Project	Oberon Sports Facility – Concept Stage
Report	Access 2019 Report
Reference	C21503-Access-r1
Date	06 September 2021
Client	Space Urban
Contact	Mark Daniels danielsm@spaceurban.com.au

Refer to Figure 31 of AS1428.1-2009 (as below) for design clarifications:

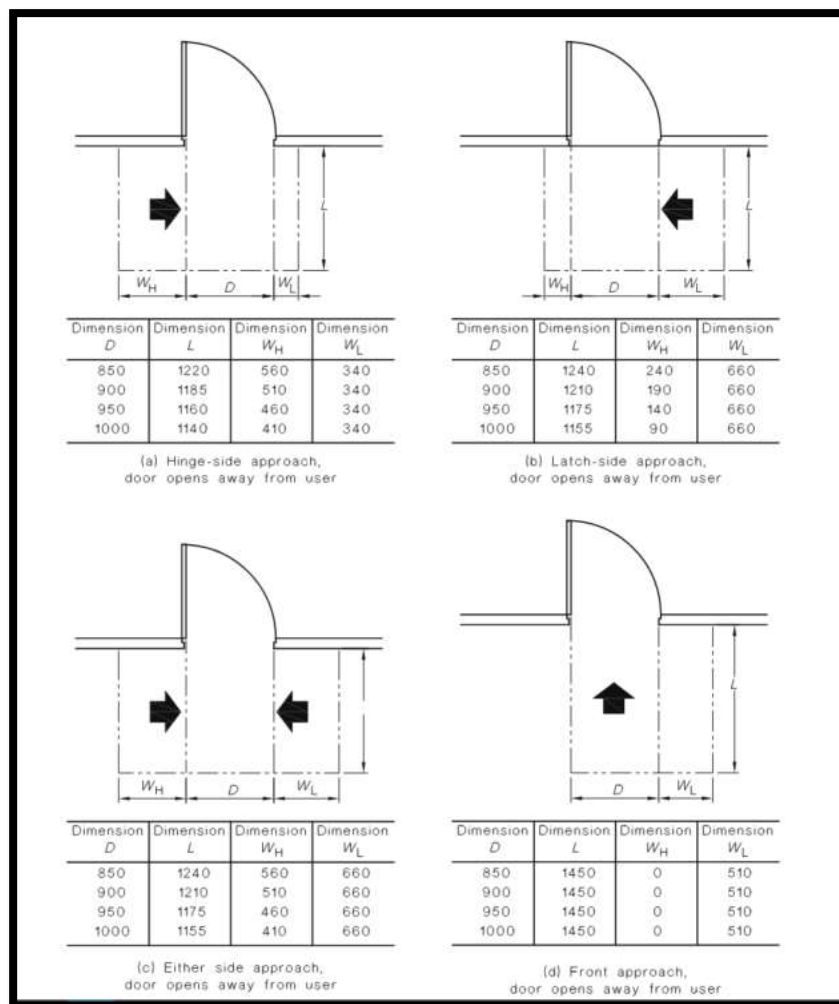
Suitable turning spaces are required to be provided at the end of corridors and within rooms in accordance with this Clause and AS1428.1-2009; being an unobstructed width of no less than 2070mm and a width of 1540mm.

Clear openings at doorways of no less than 850mm are required in accordance with Clause 13.2 of AS1428.1-2009 with circulation spaces at doorways spaced in accordance with Clause 13.3.2 of AS1428.1-2009; as detailed in Figure of AS1428.1-2009.

Detailed scaled design drawings are required to be submitted at a later design stage in order to verify compliance with the provisions of this Clause.
